SUBJECT: COUNTY REVIEW GROUP COMMENTS

PROJECT NAME: Offutt Ridge (Formerly Randall's Ridge)

RE: Item No. 168, Case No. 90-309-SPHA
Petitioner: Lavinia E. Craven, et al
Application for Zoning Variance and
Special Hearing

2ND ELECTION DISTRICT - BALTIMORE COUNTY - MARYLAND
PLAT FOR ZONING VARIANCES FOR LOT 75
PLAT 1 OFFUTT RIDGE

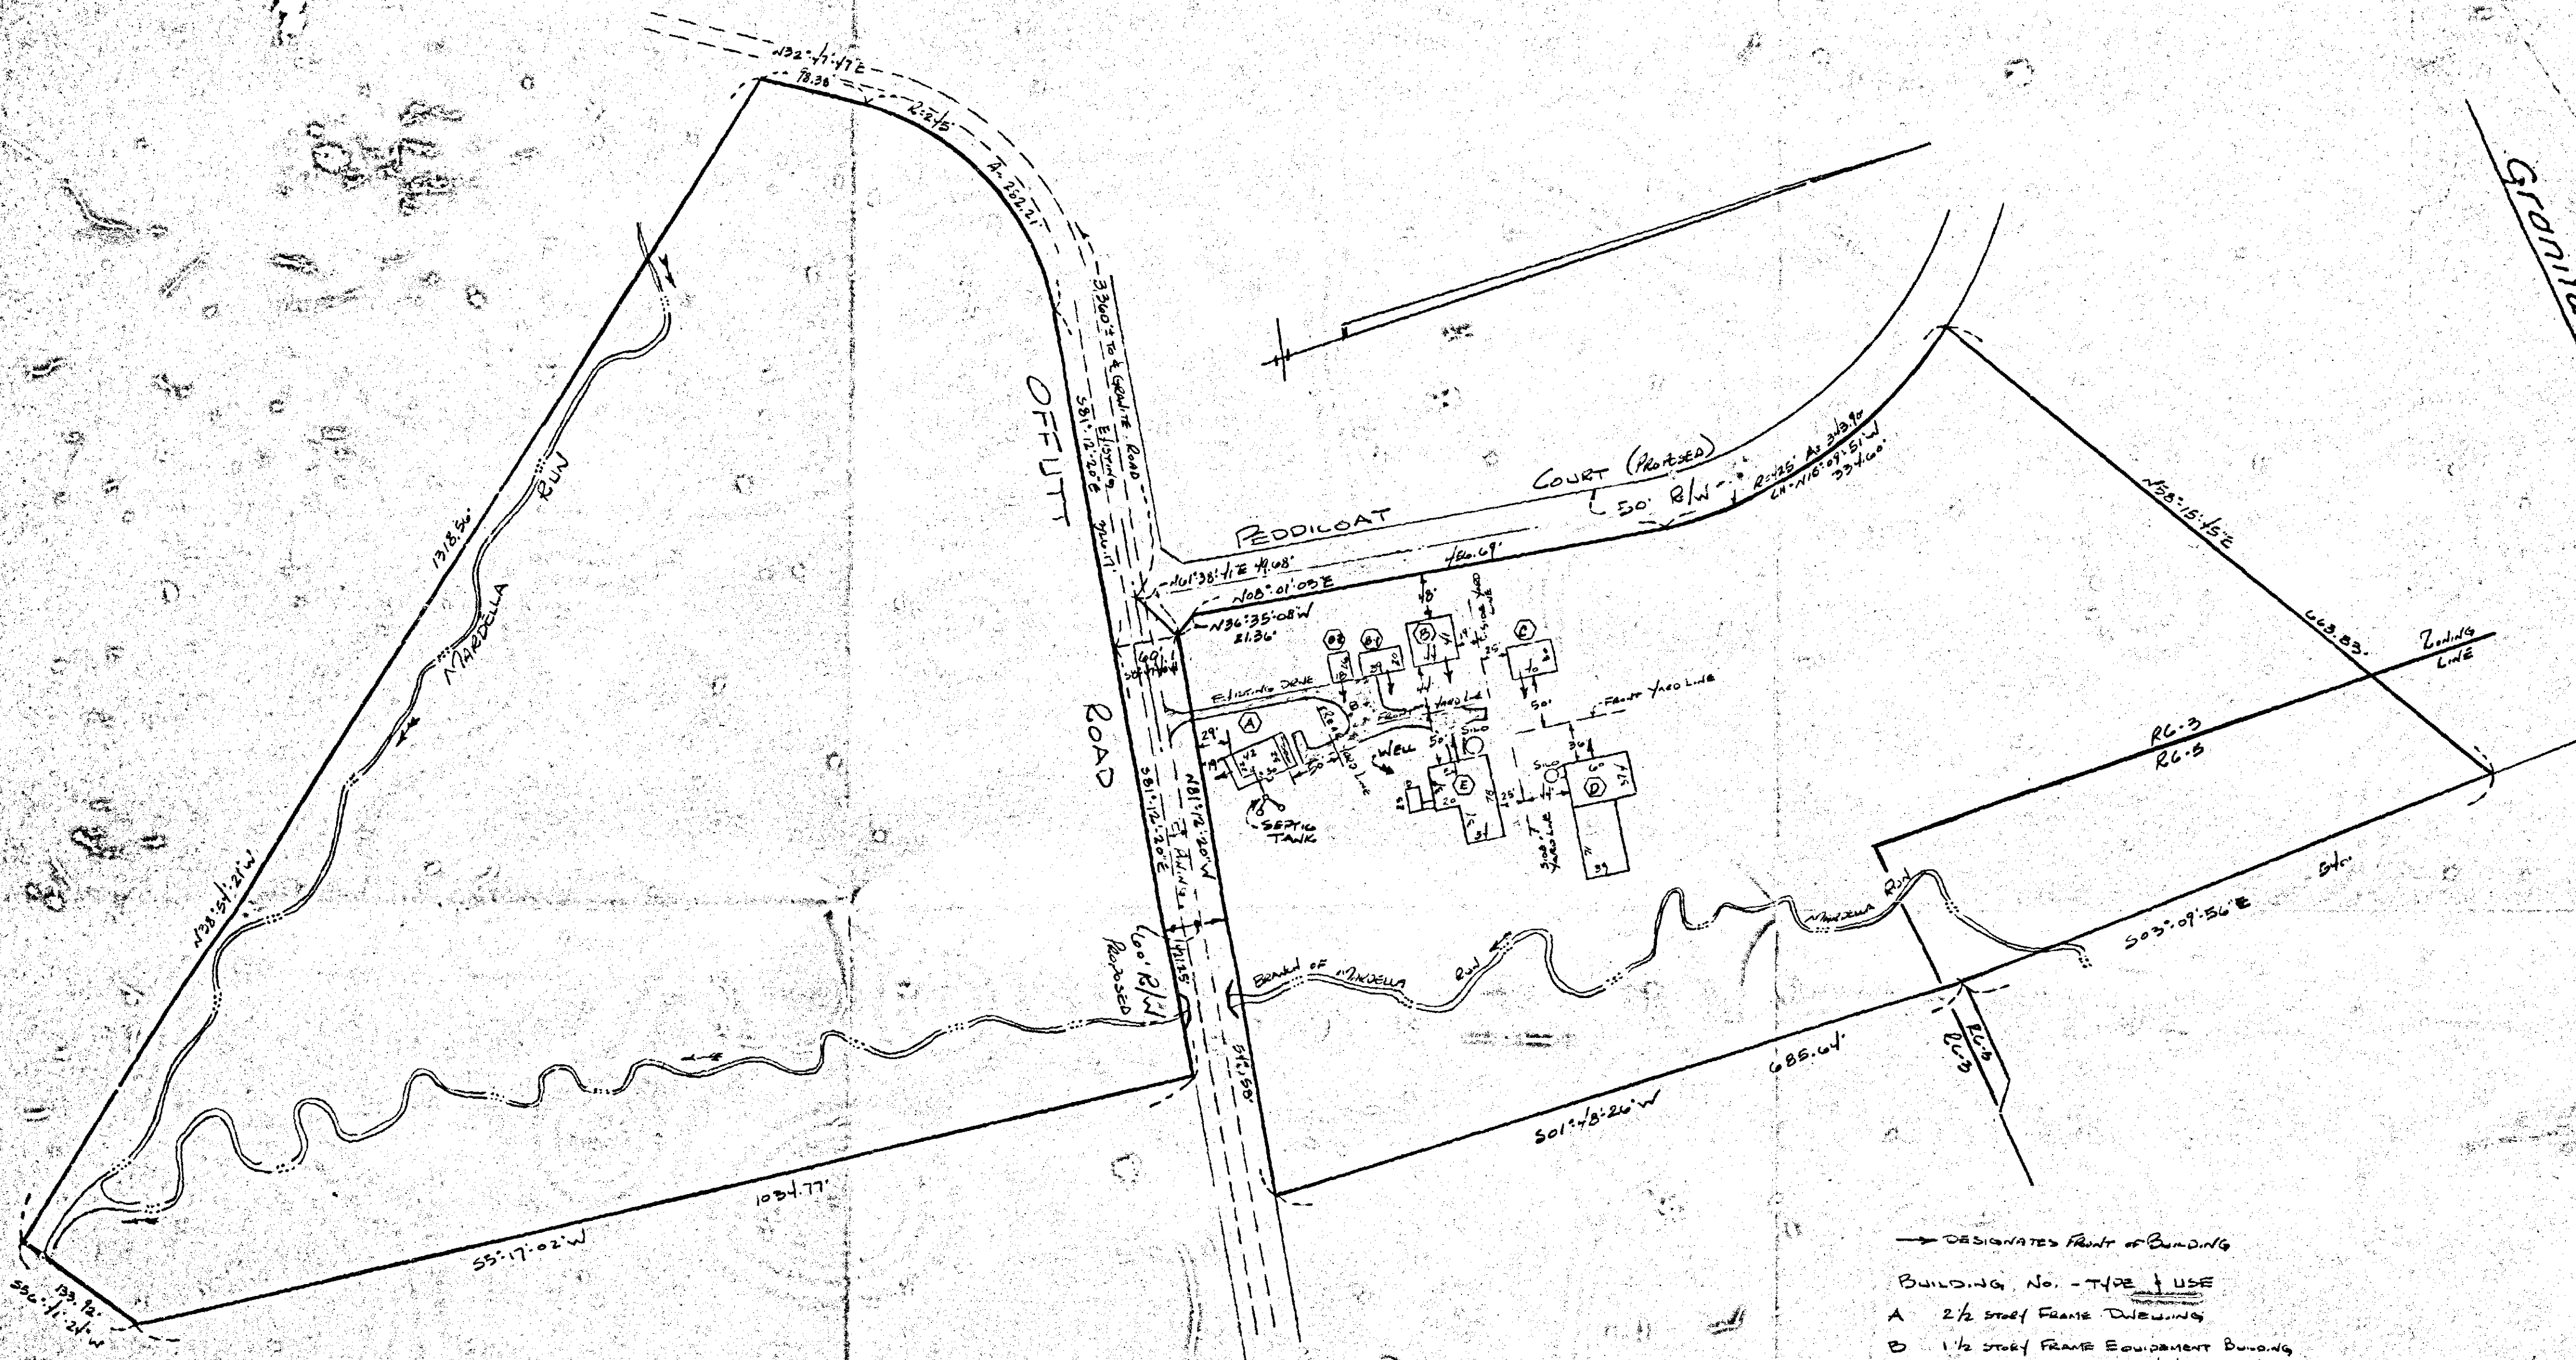
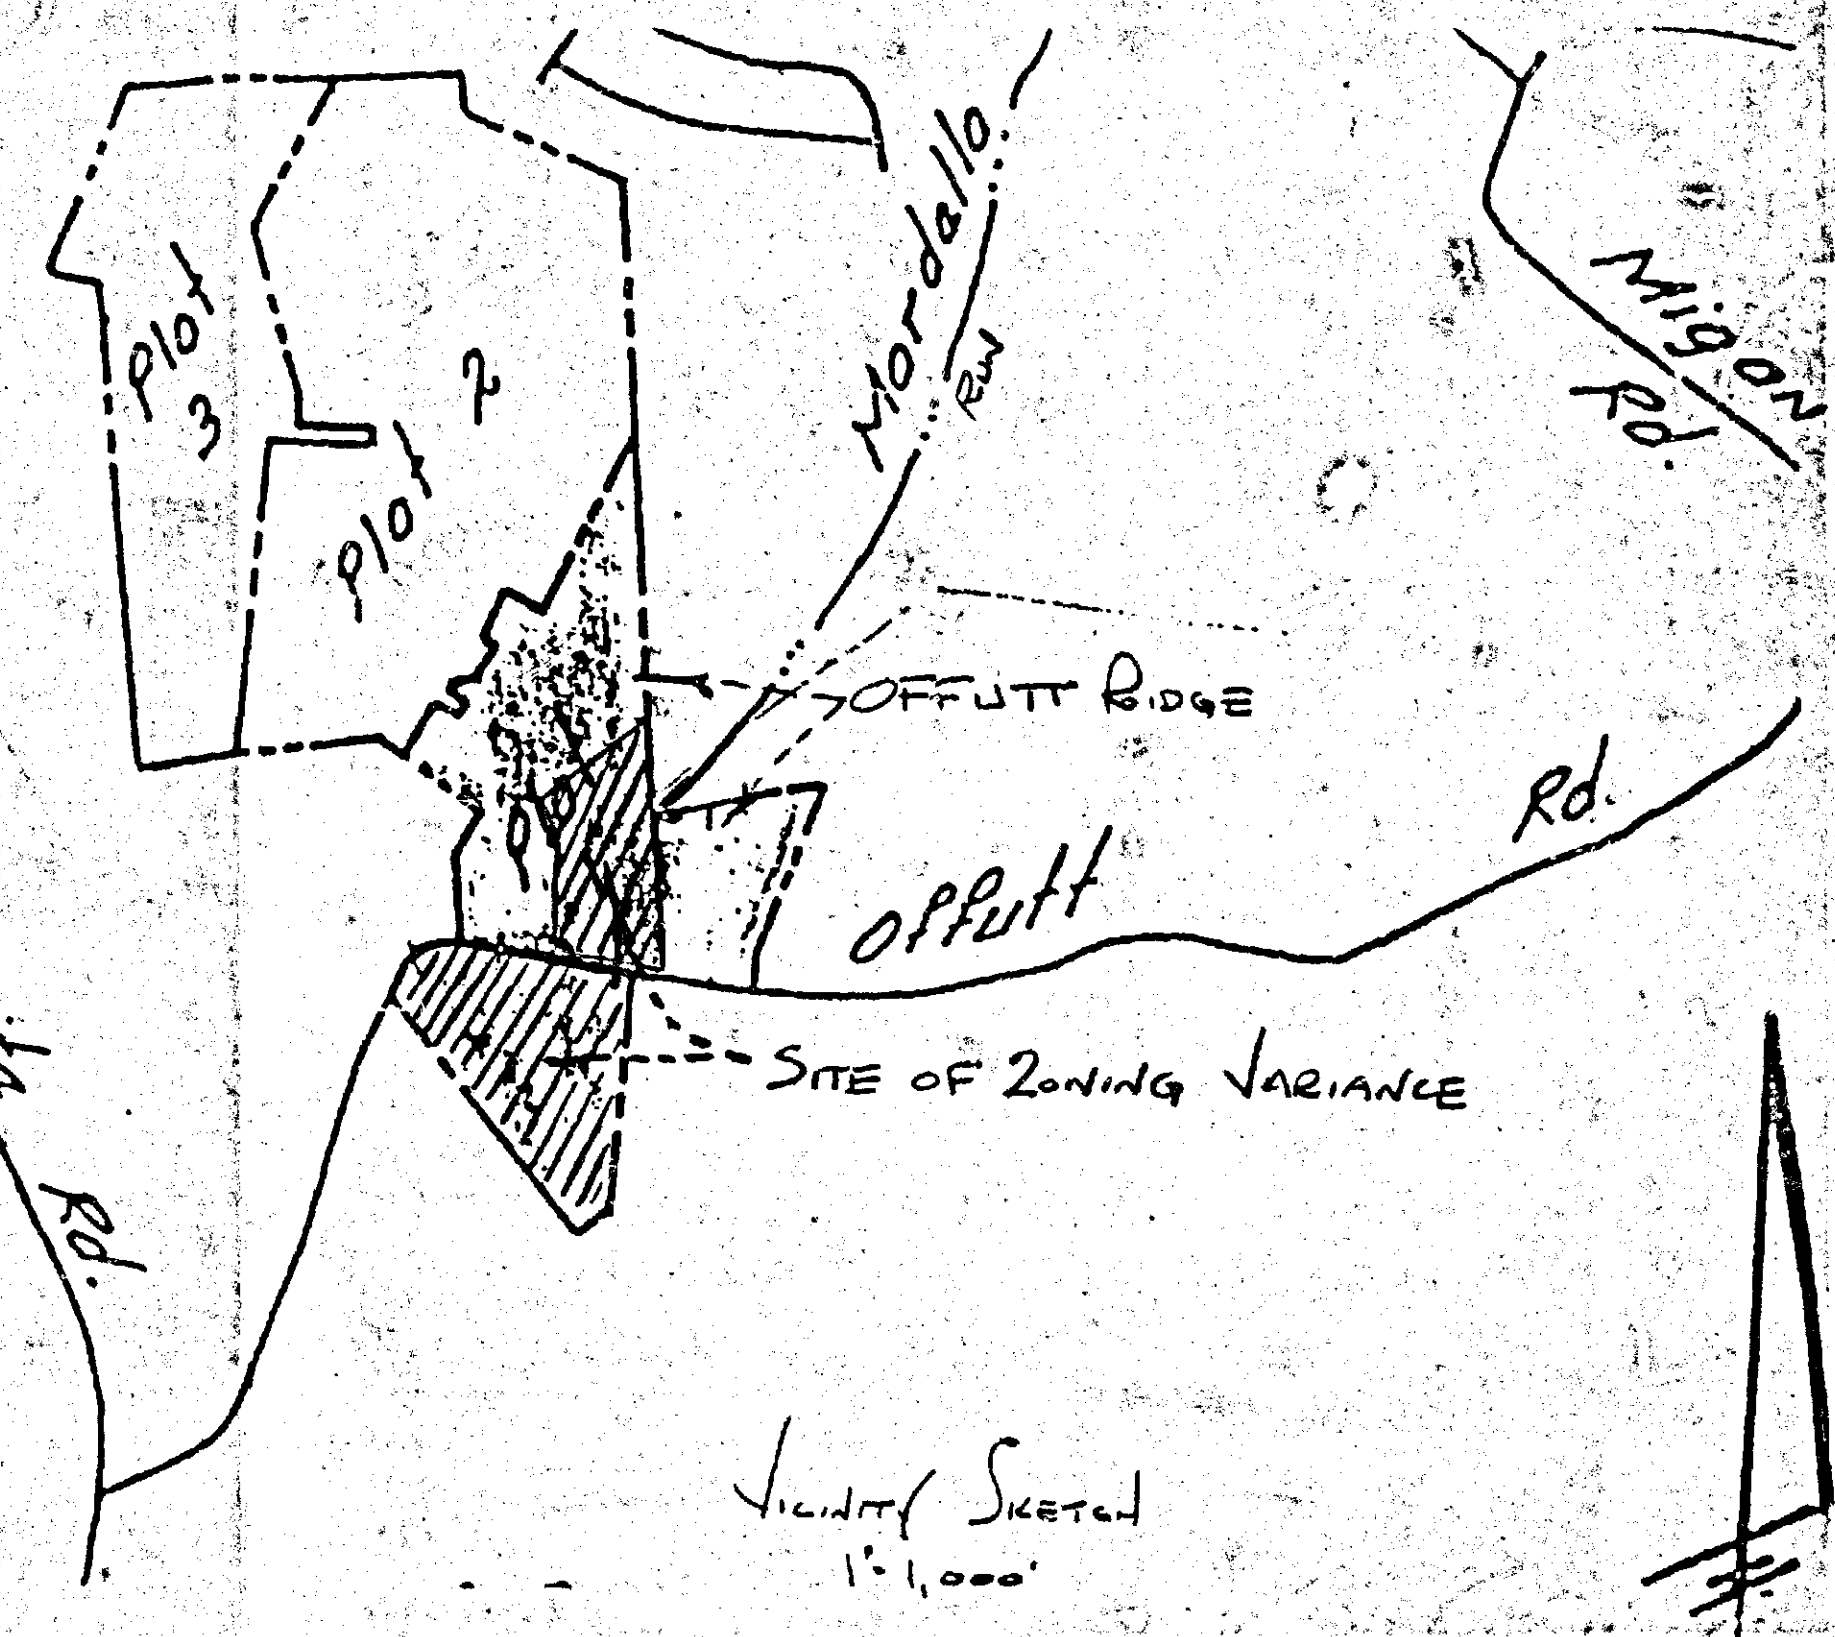
For Item 168 the property dimensions shown do not agree with plat 13/86.
